Paving & Bridge Deck Repairs - Fort Hill Road

City of Easthampton

Addendum No. 1

May 12, 2026,

METHOD OF SETTING - TYPICAL FOR ALL TYPES
SEE TYPICAL SECTIONS FOR PROJECT

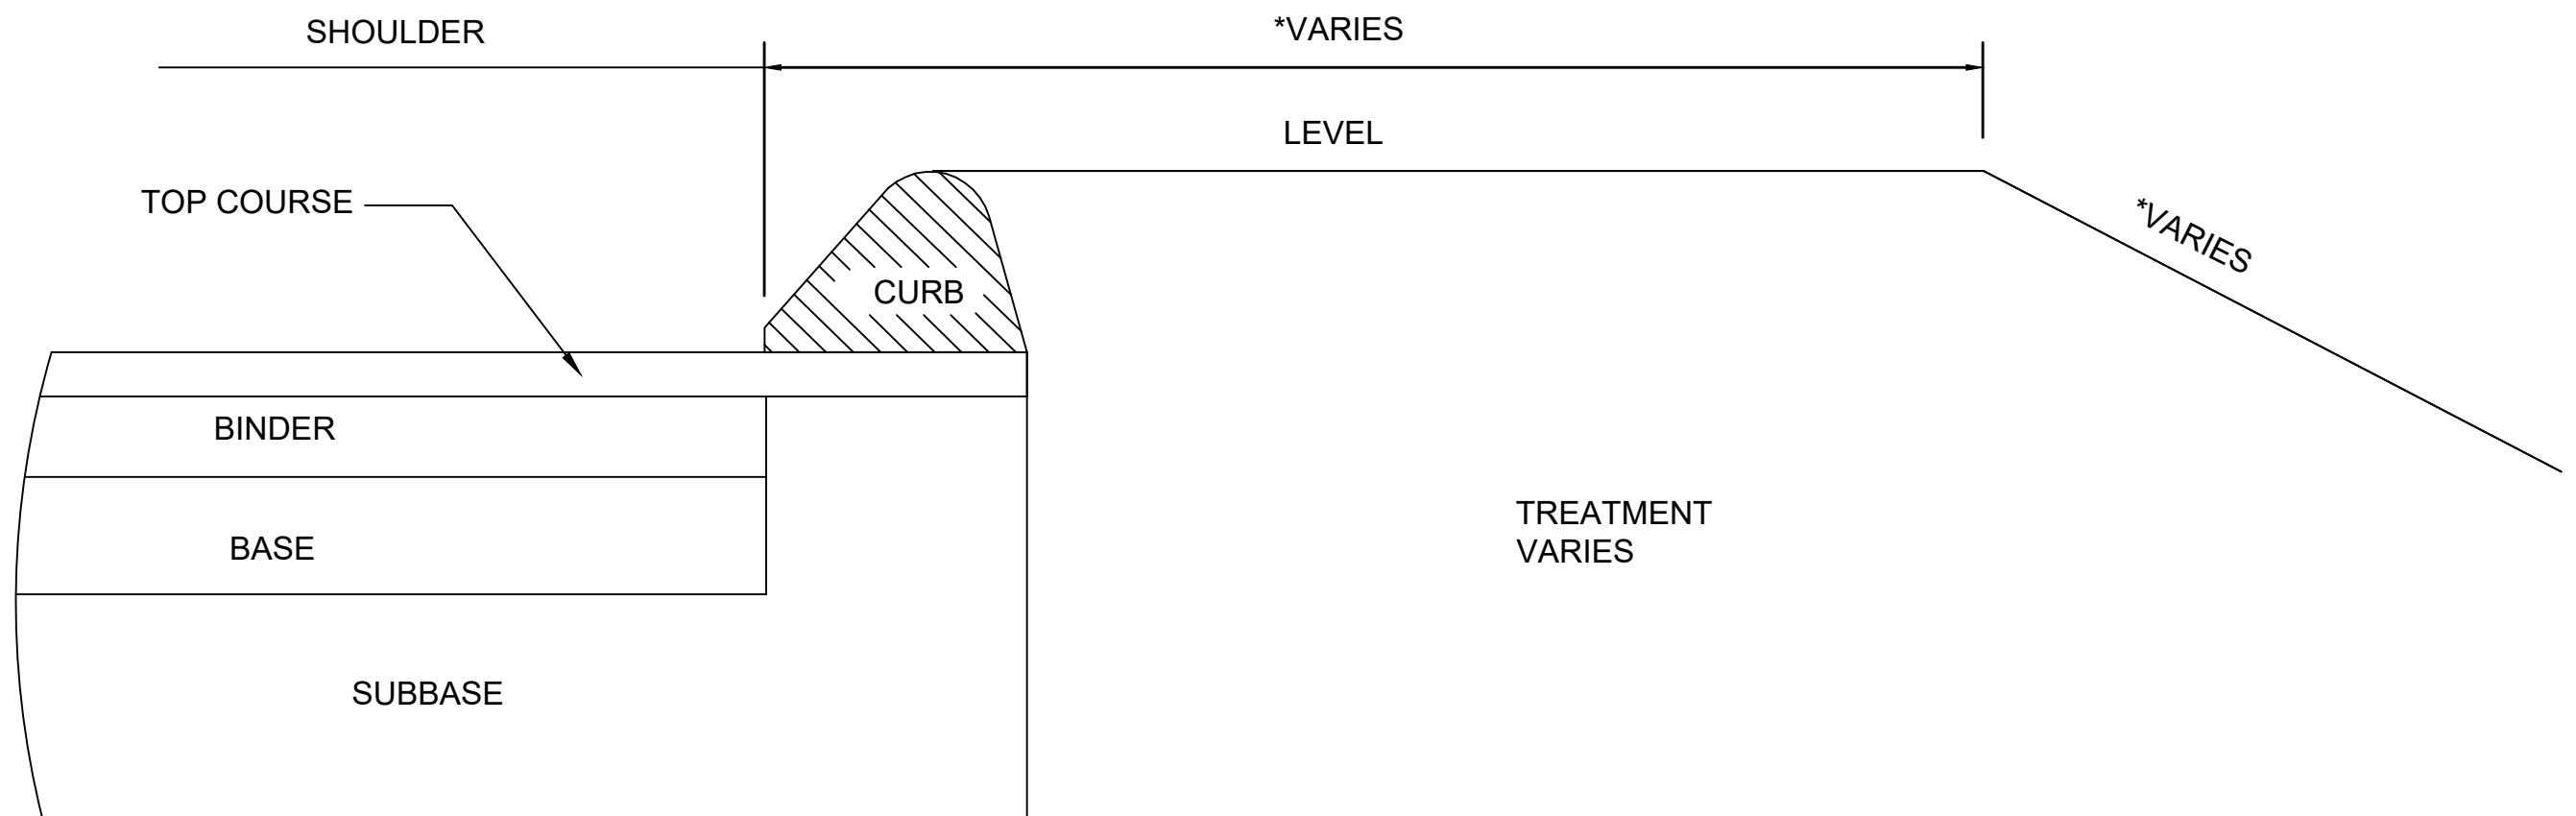
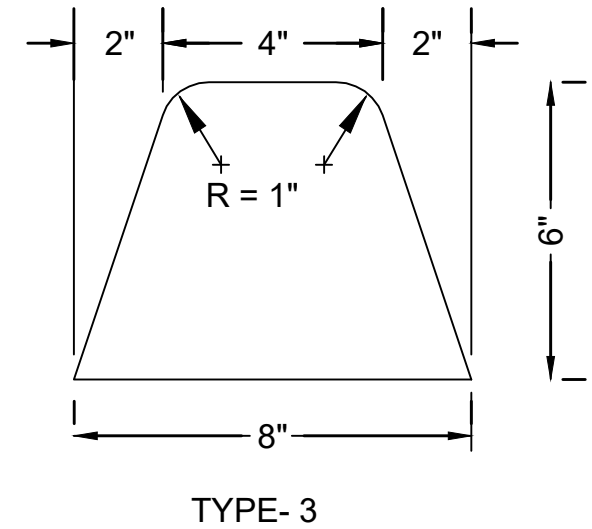
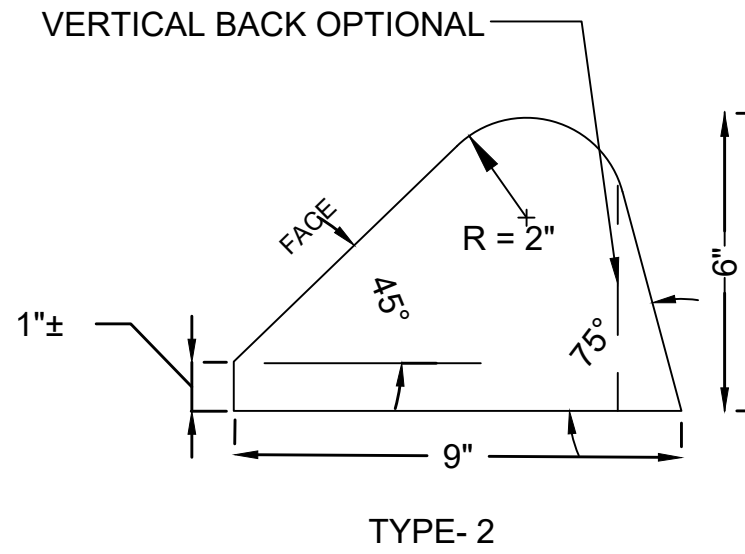
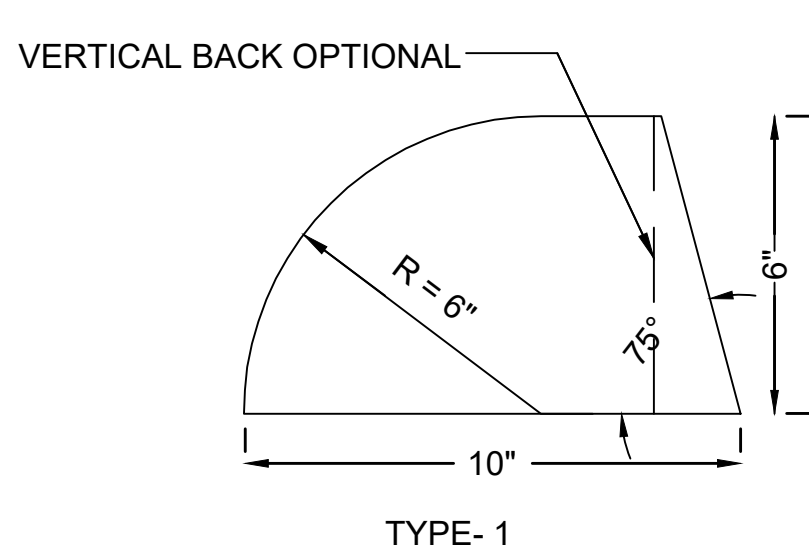
Question 7: There is an existing asphalt berm in certain locations of the project. Will this berm need to be replaced? If so, please provide a specification and item for asphalt berm.

Answer 7: Costs for replacement of the existing HMA curb, shall be considered incidental to Item 450.22 Superpave Surface Course – 9.5 (SSC-9.5). The HMA curb shall conform to MassDOT Standard Construction Detail 570.0.1 for Type-2 Curb (**attached**) and MassDOT Standard Specifications Section 500.
